SUBJECT: Forwards memo for record re stone shore revetment. Revetments considered structurally sound & stable. W/photos.

NCBED-DC Re: R.E. GINNA Nuclear Generating Plant

SUBJECT: Trip Report Concerning Stone Revetment at R.E. GINNA Nuclear
Generating Plant

INCLOSURE E
WEST REVETMENT NEAR EAST END.
LOOKING EAST. NOTE LAID UP REVETMENT

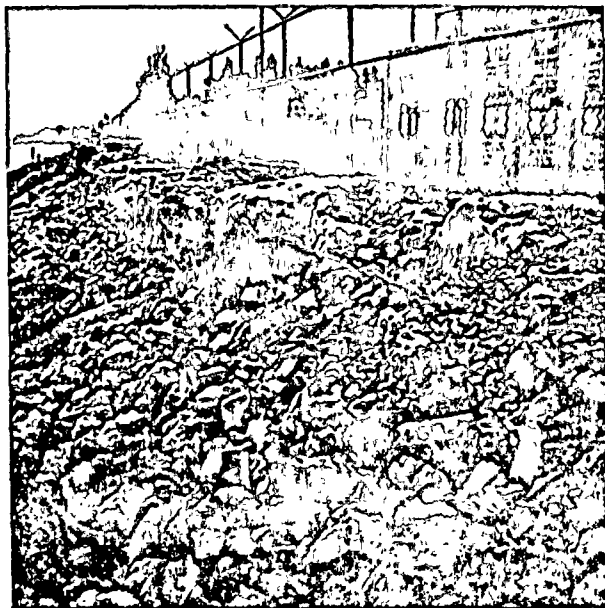
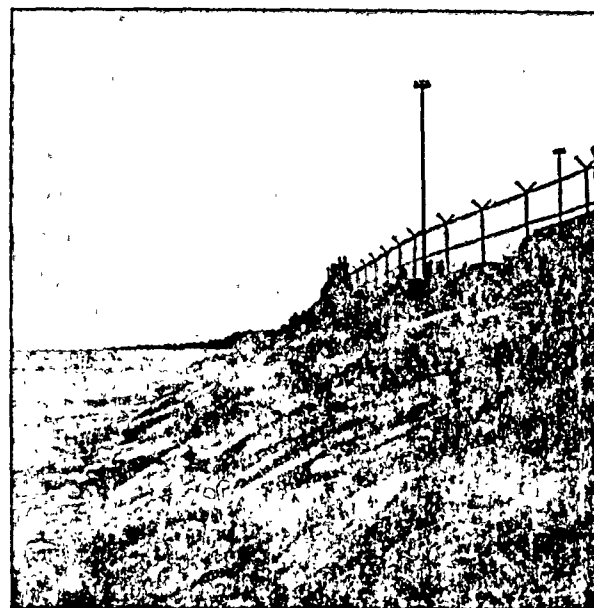
5. The inspection team walked the length of the west revetment reach and back again without noting any significant displacement of stones in the sideslope of the structure nor any unusual depressions in the structure sideslope or crest. The fence which is adjacent to the back side of the revetment appeared to be plumb and have an alignment that runs parallel to the revetment thereby indicating that there has been no appreciable movement of the fill behind or under the revetment. The armor stones on the sideslope of the revetment are covered and obscured by stone in the 4- to 9-inch range in several areas. Therefore, it was impossible to positively determine the existence of two layers of armor stones as required by the final design at these locations, particularly at the west end of the revetment where a larger concentration of the estimated 4- to 9-inch stone had been placed. Photographs were taken of the west revetment reach to depict the condition of the wall and are attached as Inclosure E.

WEST END OF WEST REVETMENT -
LOOKING WEST. NOTE SMALL STONE
FILL OBSCURING TOP ARMOR STONES.

NEAR CENTER OF WEST REVETMENT -
LOOKING WEST. NOTE LAID-UP REVETMENT
ON RIGHT AND CAP STONES ON LEFT.

WEST REVETMENT NEAR EAST END -
LOOKING EAST. NOTE SMALL STONE
FILL OBSCURING TOP ARMOR STONES.
SCREEN HOUSE IS AT RIGHT.

INCLOSURE F
EAST REVETMENT - LOOKING EAST, NEAR EAST END. NOTE LAID - UP REVETMENT, ROW OF CAP STONES.

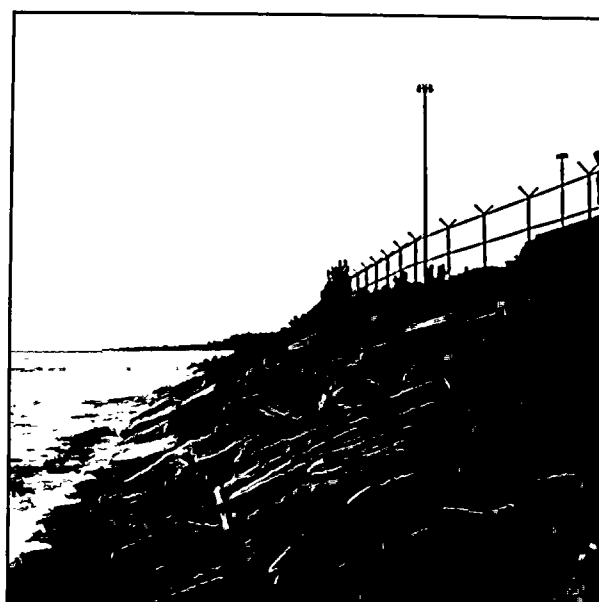
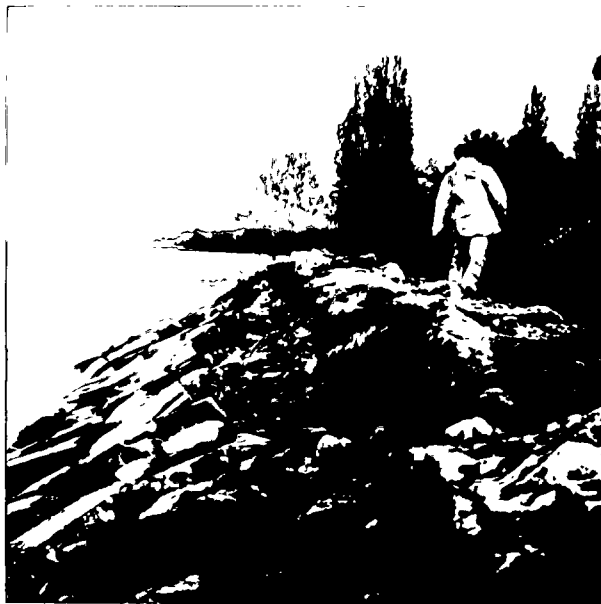
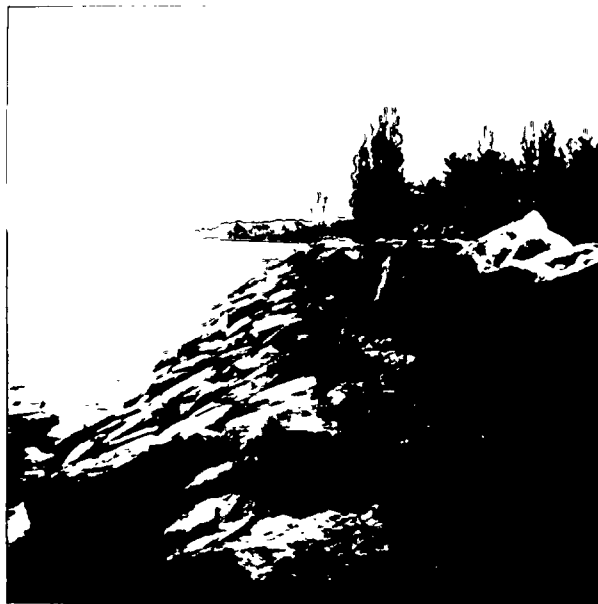
6. The inspection team also walked the length of the east revetment reach and back, again without noting any significant displacements of stones in the sideslope of the structure nor any depressions in the structure sideslope or crest. There were no apparent depressions or slippages evident in the backslope of the compacted earth dike, thereby indicating that there has been no appreciable movement of the fill behind or under the revetment. However, a large void, large enough for a person to crawl into, was observed roughly 100 feet east of the west end of the east revetment reach. This void extends for about 25 to 30 feet directly under the capstones which bridge the void with little rock to rock contact over the void. The two layers of 5-ton minimum armor stones on the sideslope of the east revetment are also covered and obscured by stone in the 4- to 9-inch range in a few areas. The main concentration of the 4- to 9-inch stone on the east revetment was placed in the area adjacent to the discharge canal. It was again impossible to determine the existence of two layers of armor stones in these areas where the 4- to 9-inch stones exist. Photographs were taken of the east revetment reach to depict the condition of the wall and are attached as Inclosure F.

and, except for possibly the area in the east revetment reach where the large void exists, there is no evidence of any structure stability problem. A determination could not be made at the time of the inspection as to whether two layers of armor stones exist in the areas where the smaller stones had been placed. According to Mr. Gary Goetz, this small stone had been placed to form a roadway in the lee of the structure during the early 1970's for equipment used to place the cap stone. Upon completion of the cap stone placement, the roadway stone was dumped over the face of the revetment to fill the voids between armor stones, thereby making a more aesthetically looking revetment.

10. The area in the vicinity of the large void in the east revetment reach will be reexamined during the 13 November 1981 inspection. Our assessment of structural adequacy and any recommendations will be presented in the future letter report.

EAST REVETMENT @ WEST END. NOTE SMALL STONE FILL OBSCURING ARMOR STONES. CAP STONE @ LEFT. DISCHARGE CANAL VISIBLE IN REAR, LOOKING WEST.

EAST REVETMENT APPROX. 100 L.F. EAST OF WEST END. NOTE LARGE VOID UNDER CAP STONE (THIS VOID EXTENDS A TOTAL LENGTH OF ABOUT 25 L.F. TO RIGHT & LEFT OF PHOTO).

EAST REVETMENT NEAR EAST END - LOOKING EAST. NOTE SMALL STONE FILL OBSCURING TOP ARMOR STONES, LAID UP REVETMENT @ LEFT, CAP STONES @ RT.

9. These preliminary findings have been already discussed between Mr. Gary Staley of NRC and Mr. Richard Gorecki of Buffalo District, Corps of Engineers. In order to verify that the revetment is of adequate design in the areas where the small stone had been placed, it will be necessary to have the licensee remove the small stone. After the small stones are removed, another site visit will be required to visually inspect the revetment and insure that the armor stones are in place. This second site visit has been tentatively set by Mr. Gary Staley for 13 November 1981.
